BOARD OF ZONING APPEAL

BZA Application Form

LOCATION OF PROPERTY: 18 Clinton St., Cambridge, MA

Raise the base of the foundation of rear portion of structure out of the high water table, resulting in an increase in Height of rear portion of the structure located within setbacks, requiring a special permit.

2 PROPOSED - EAST ELEVATION - REVISION
1/4" = 1'-0"

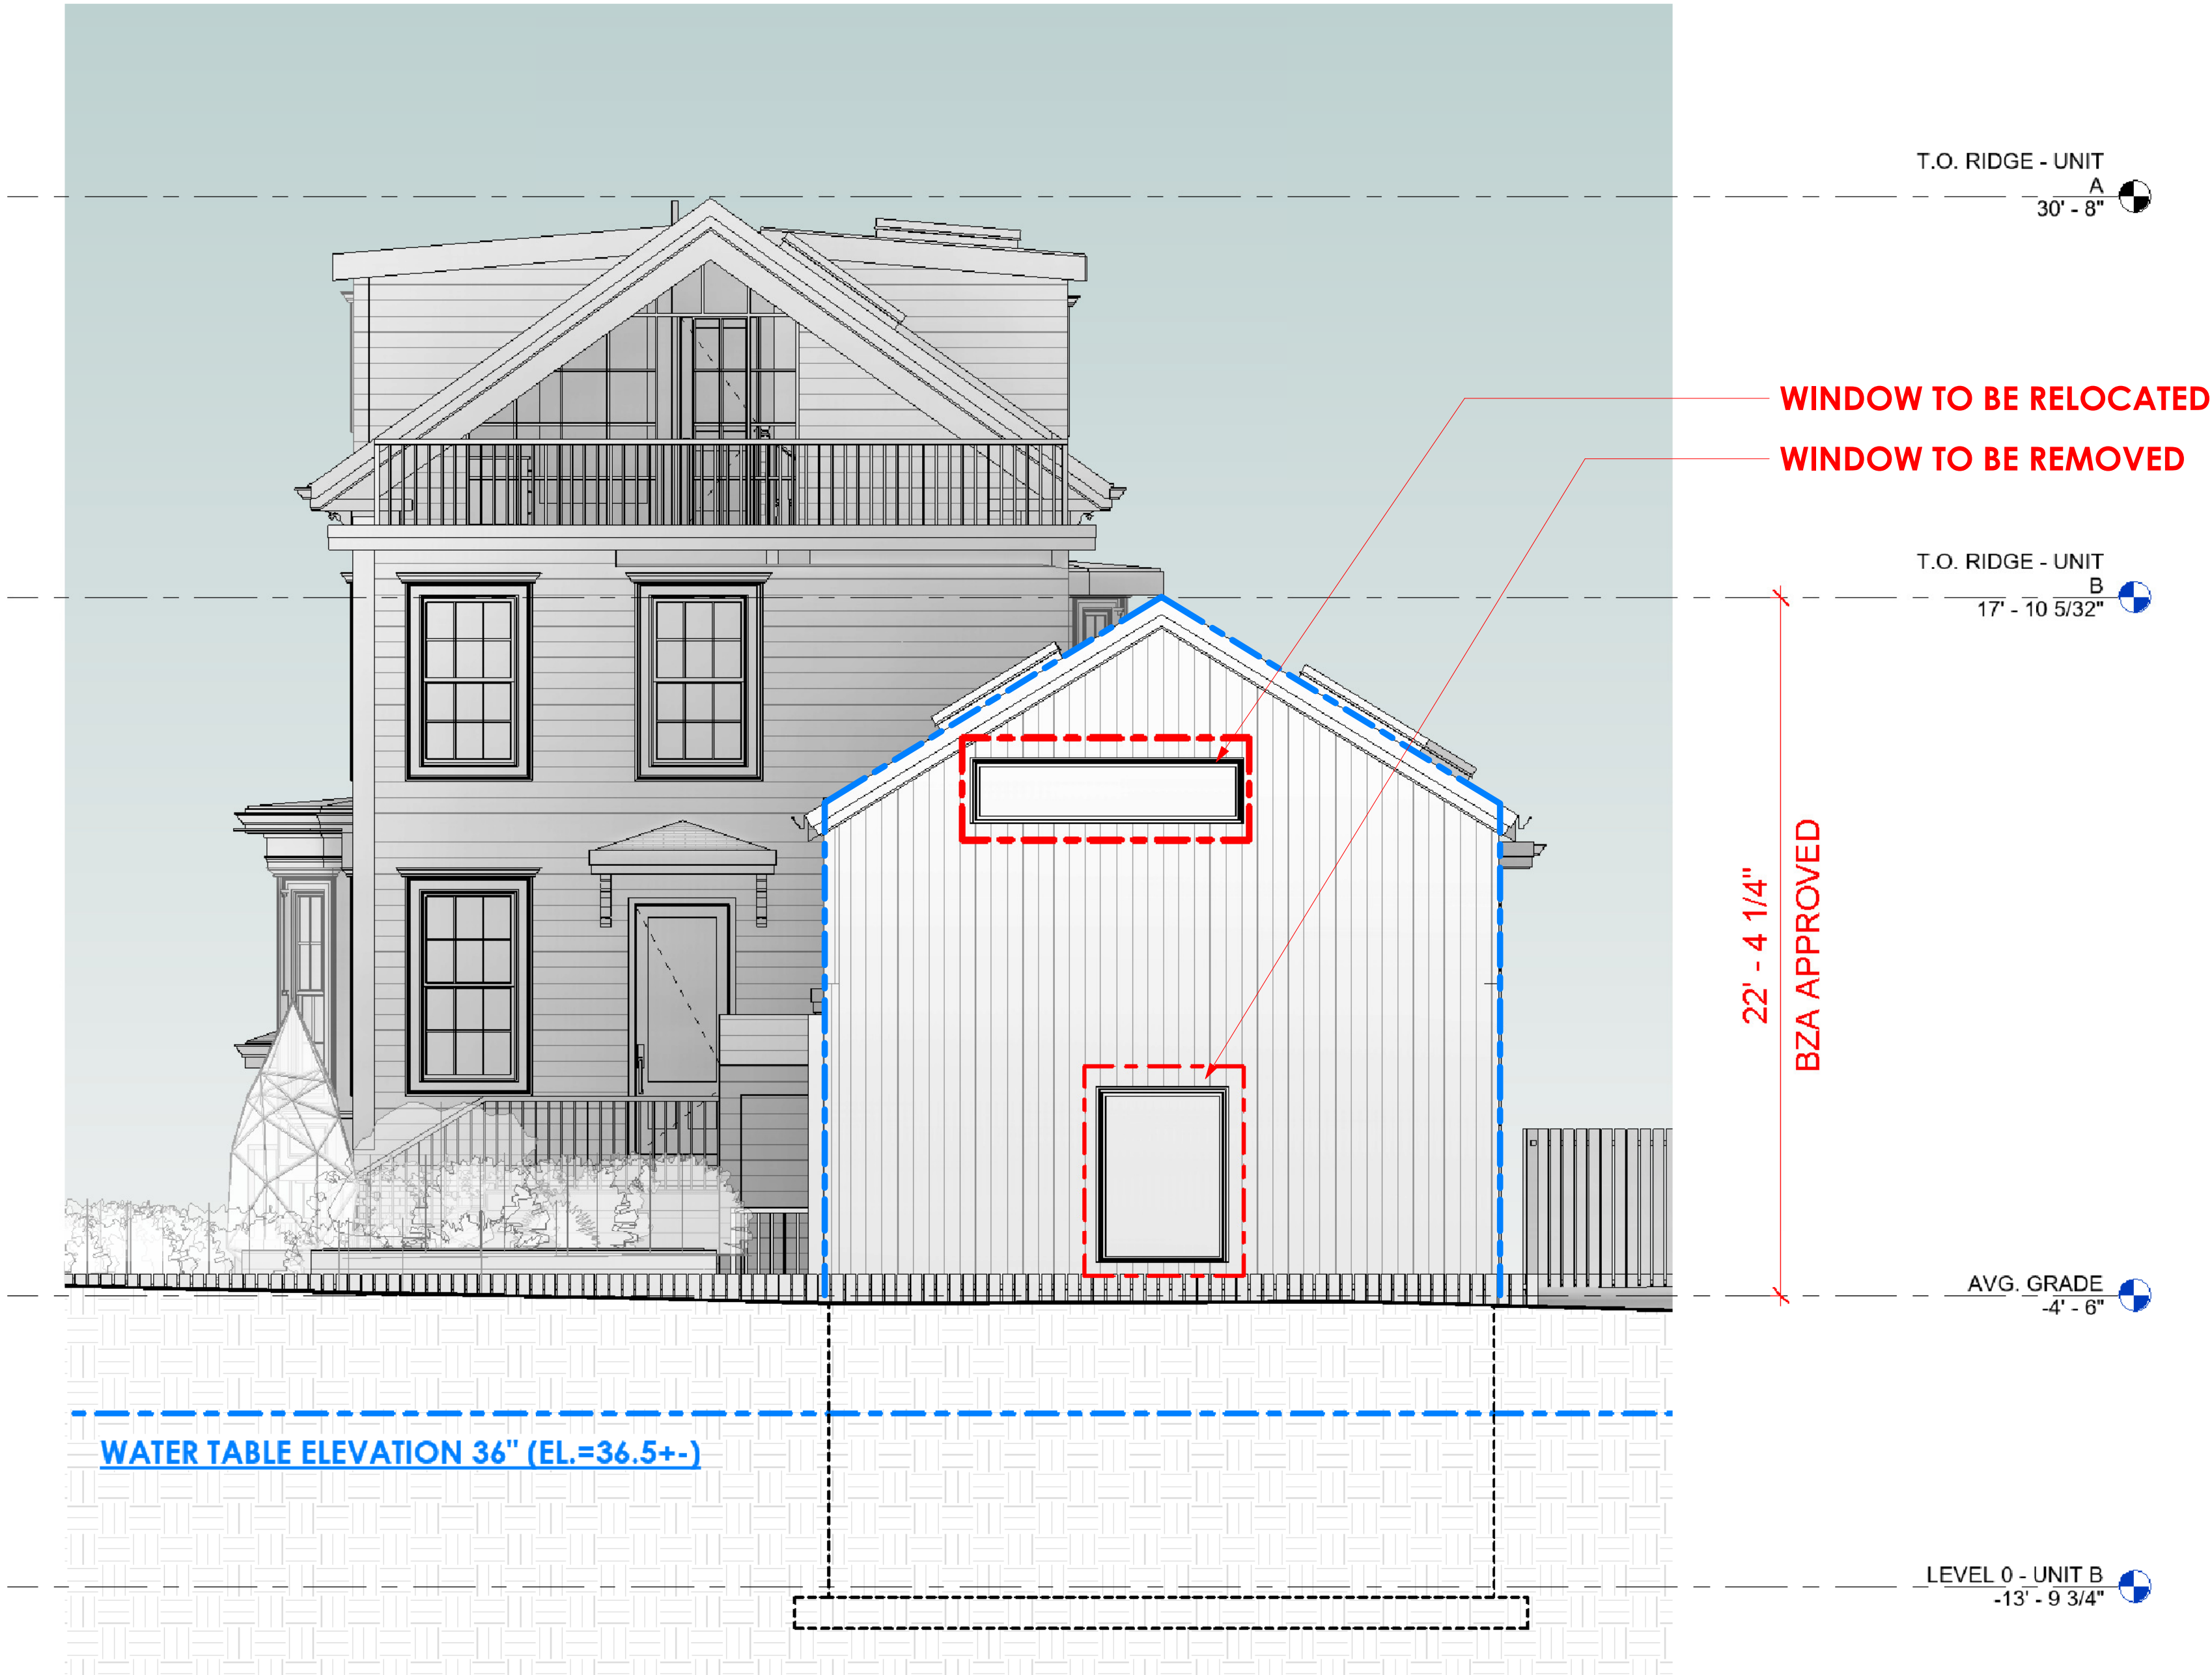
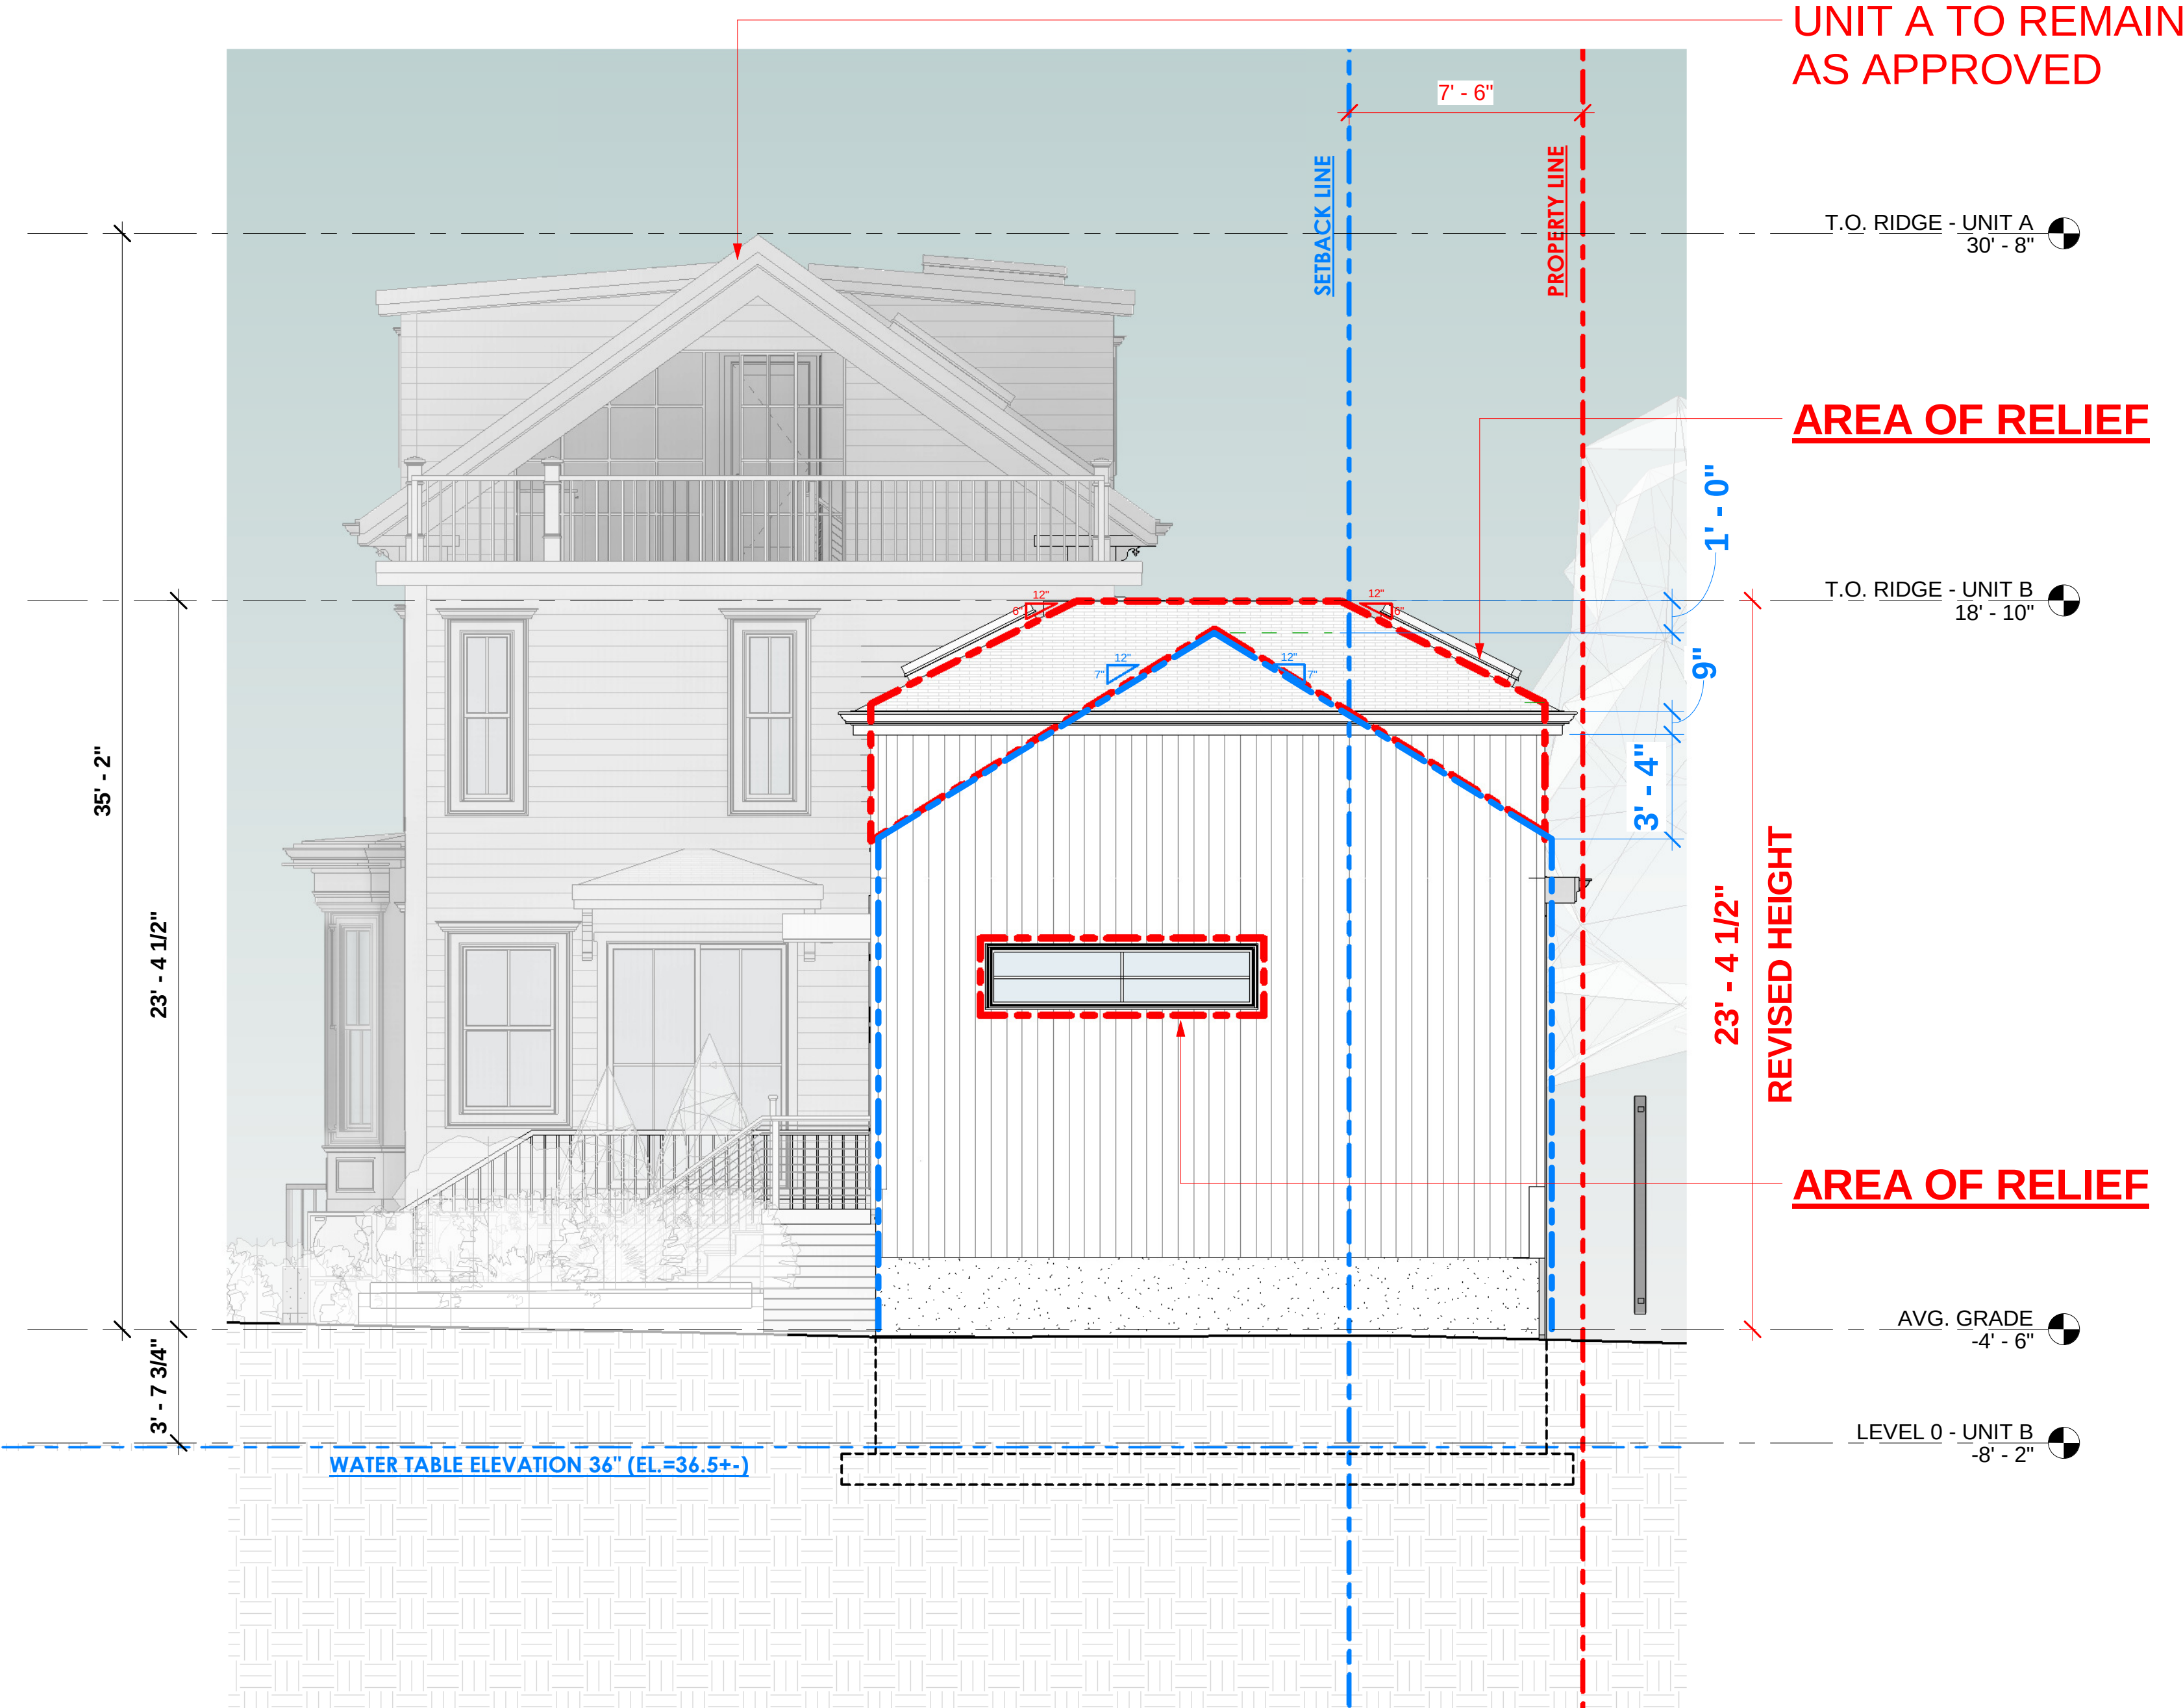
10 SARAH RHATIGAN: And so, what they -- what the
11 folks at 20 Clinton Street are talking about is that, you
12 know, the side -- they're seeing more siding at the plane
13 that's closer to their home.
